## 106-18-CA

601 ELM STREET  
OAKWOOD HISTORIC  
DISTRICT (R-10)

## APPLICATION FOR A CERTIFICATE OF APPROPRIATENESS – STAFF REPORT

Nature of Project: Demolish shed; construct garage; construct driveway; remove tree

SOUTH ELEVATION  
3/16" = 1'0"

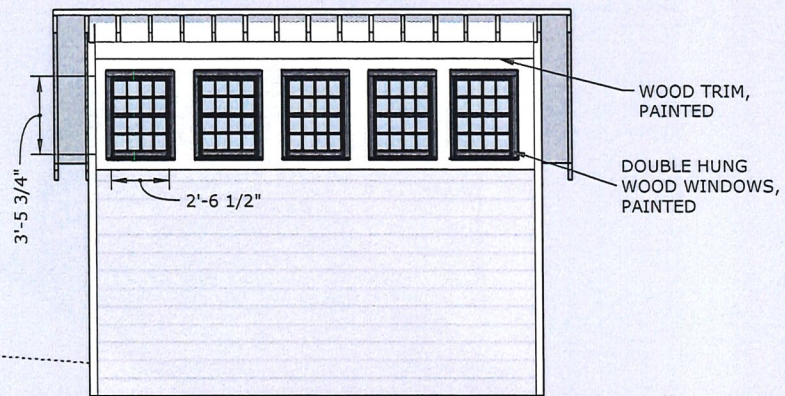
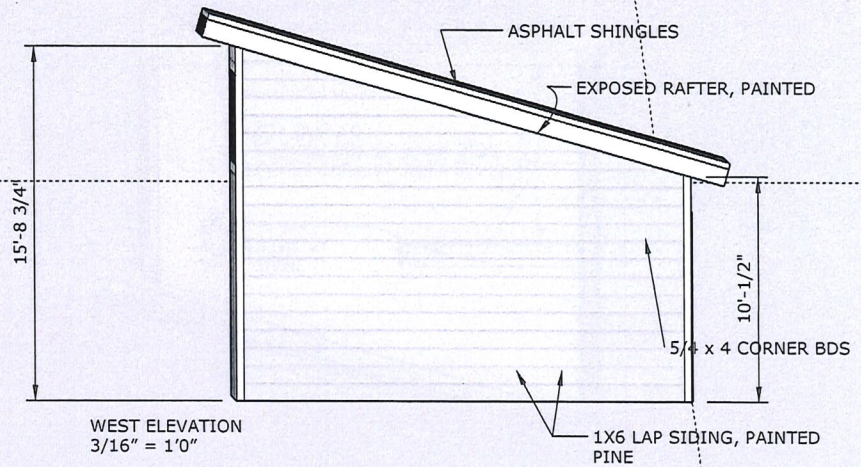
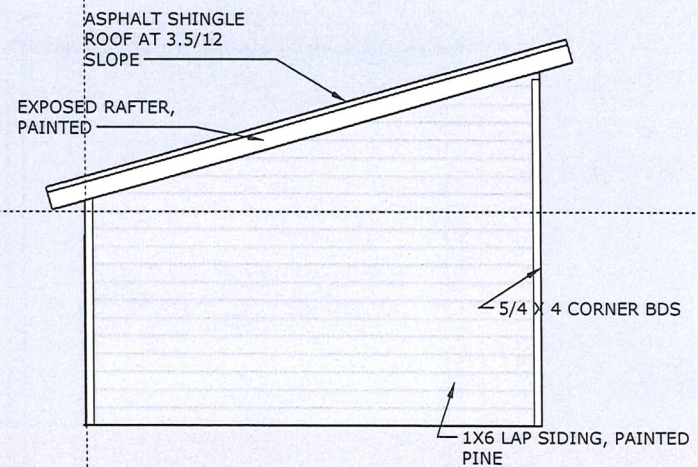
- 5\* The form of the garage is a steep shed roof with clerestory windows on the rear of the structure (facing the north property line).

- 6\* Although not as common, shed roofed garages are seen in Oakwood. A historic example exists, though oriented differently, at 410 N Elm. The applicant did not provide any examples of garages with similar forms.
- 7\* The height of the proposed garage is 15' 8 ¾" to the top of the wall at the south elevation and 10' ½" to the top of the wall at the north elevation. The height dimension does not take into consideration the thickness of the roof.
- 8\* The applicant did not provide a built area to open space analysis or a built mass to open space analysis. However, based on the new footprint increase, the garage will add 40 SF of built mass – not a significant increase.
- 9\* No specifications for windows or doors were provided.
- 10\* No information was provided regarding exterior lighting, if any.

3. That prior to the issuance of the blue placard the following be provided to and approved by staff:
  - a. full documentation of the building with photographs and measured, scaled drawings;
  - b. driveway plan and materials;
  - c. a tree protection plan.
4. That details and specifications for the following be provided to and approved by staff prior to installation or construction:
  - a. Manufacturer's specifications for garage vehicular door, showing both section and elevation views, and material descriptions;
  - b. Manufacturer's specifications for the clerestory windows;
  - c. Manufacturer's specifications for exterior lighting, and location on building

Current

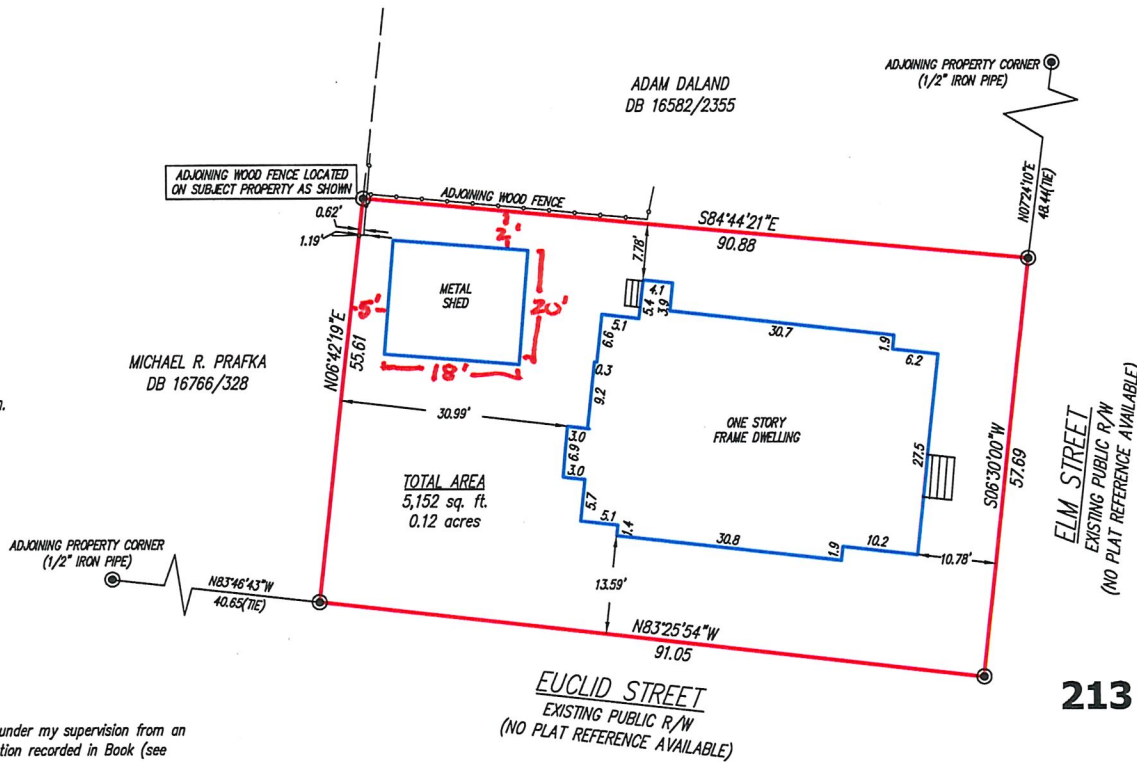
2. What is the address for the example driveway that you included in your application?  
**Unknown. I found it online while looking for ideas.**
3. After reviewing your survey documents, it appeared that there was a discrepancy between the way the survey was drawn and the measurements handwritten in. Which measurement was accurate – the 2' from the property line or the shed as drawn? Please submit a correct site plan. Please also include the driveway as it currently exists on the plan. **Apologies for the confusion. Attached is a detailed drawing with measurements. The two foot vs 5 foot discrepancy stems from my omission of an additional storage structure built onto the back of the shed. The driveway, as it currently exists is only a curb cut and "grass".**

4. Submit a plan that shows the topography of the site. **Attached.**
5. Please include a tree protection plan and, if any exist, please identify any trees on the property on the site plan. If there are no trees that are 8" DBH or greater located on the property, please let us know. **There is only one tree greater than 8" DBH. It is shown on my updated survey markup and is growing into the current shed. It is an Ailanthus tree and I would like to remove it.**

# Example Driveway

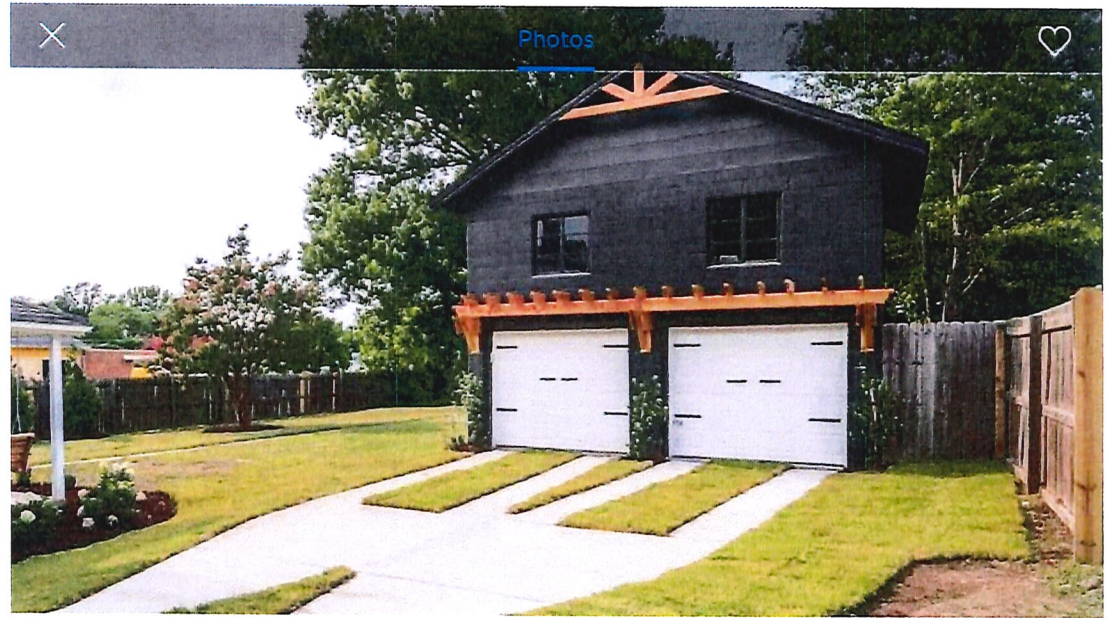
- 4\* The example driveway provided in the application is not located in Oakwood.
- 5\* A driveway similar to the example provided that separates from one driveway into two-wheel strip parking areas was approved for 608 Oakwood Avenue through COA 125-13-CA. The installed driveway has brick wheel strips and concrete fill.
